PCN# 20130905002
Qualification of 8mm Tape width and 7 inch Reel diameter for
Select Devices on QFN and SON Package
Information Only

PCN Number:	20130905002			PCN Date:	09/13/2013
Title:	Qualification of 8mm Tape width and 7 inch Reel diameter for Select Devices on QFN and SON Package				
Customer Contact:	PCN Manager	Phone:	+1(214)480-6037	Dept:	Quality Services
Change Type:					
☐	Assembly Site	☐	Assembly Process	☐	Assembly Materials
☐	Design	☐	Electrical Specification	☐	Mechanical Specification
☐	Test Site	☒	Packing/Shipping/Labeling	☐	Test Process
☐	Wafer Bump Site	☐	Wafer Bump Material	☐	Wafer Bump Process
☐	Wafer Fab Site	☐	Wafer Fab Materials	☐	Wafer Fab Process
		☐	Part number change		
PCN Details					
Description of Change:					
Packing Material Qualification for 8mm tape width and 7 inch Reel diameter for select devices on QFN and SON package. Packing material differences are shown below. Current Packing for full SPQ (3ku) – 13 inch reel diameter  ➔  Proposed Packing for full SPQ (3ku) – 7 inch reel diameter  ➔  ▪ R-Version devices- with full SPQ (3000u per reel)

TO CARRIER TAPE: 4136158-0149

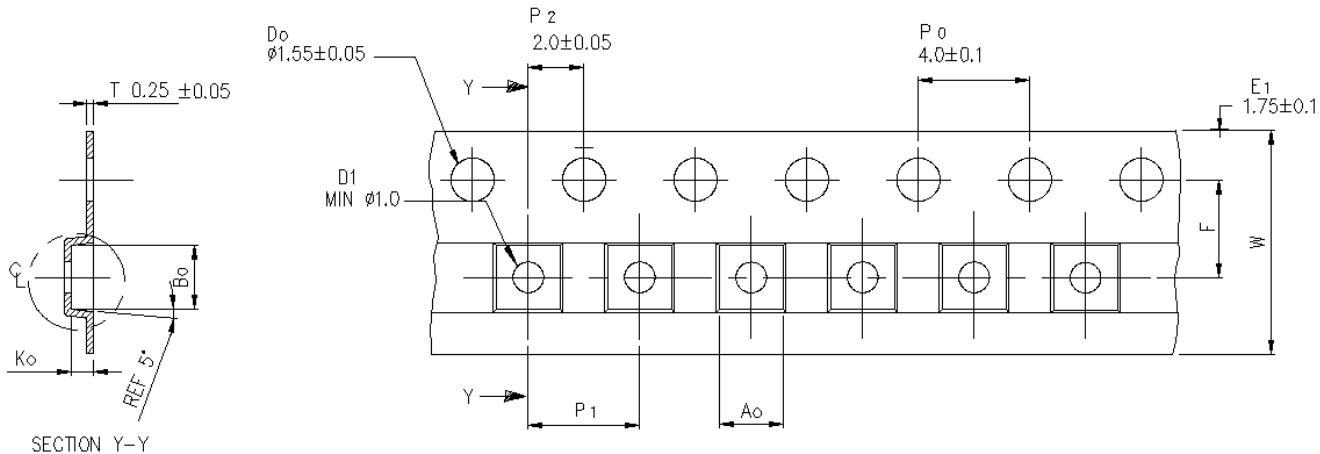
Carrier Tape “From/To” Detail

Ao	2.30	+/- 0.05
Bo	2.30	+/- 0.05
Ko	1.15	+/- 0.05
F	3.50	+/- 0.05
P1	4.00	+/- 0.10
W	8.00	+/- 0.10

7 Inch Reel Drawing (TI P/N: 4203839-0005)

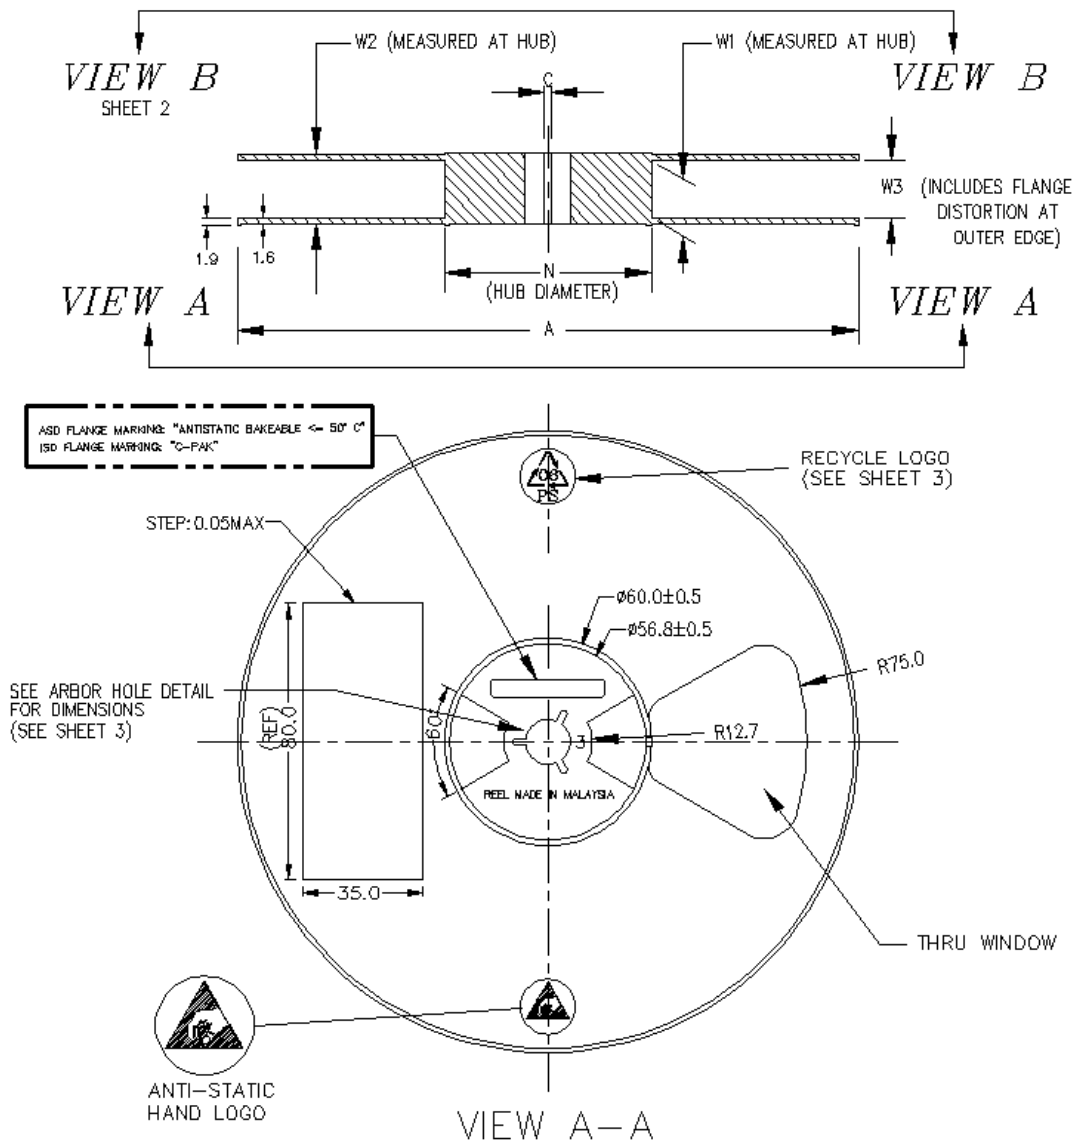
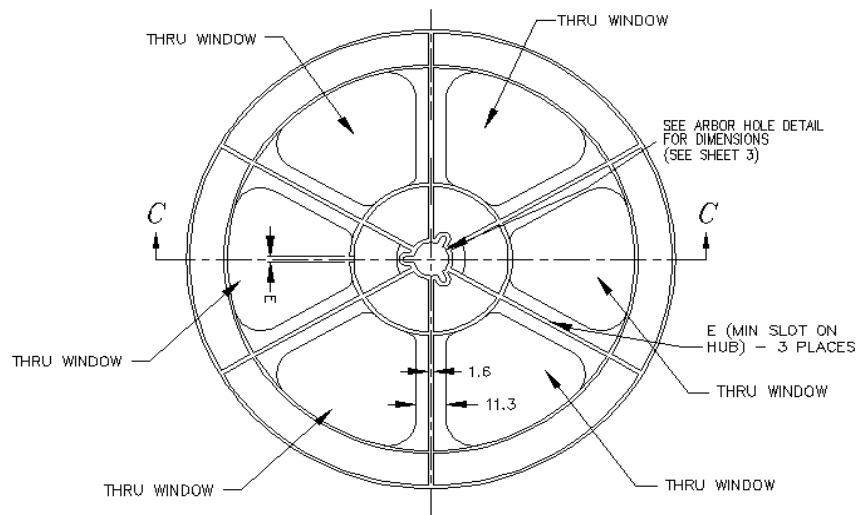
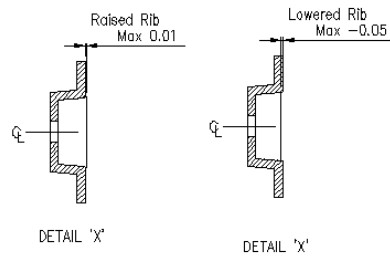
MAT'L REV LTR	PART NUMBER	SUPPLIER PART NUMBER	MATL TYPE	ESD TYPE	TAPE SIZE (MM)	A (MAX.)	B (MIN.)	C (± 0.2)	D (MIN.)	E	N (MIN.)	W1	W2 (MAX.)	W3 (MIN./MAX.)
A	4203839-0005	7E2 M08 BK CP/ASL	PS	ASD	8.0	180	1.5	13.0	20.2	4.0 ± 0.1	60.0	8.4 +1.5/-0.0	14.4	7.9/10.9
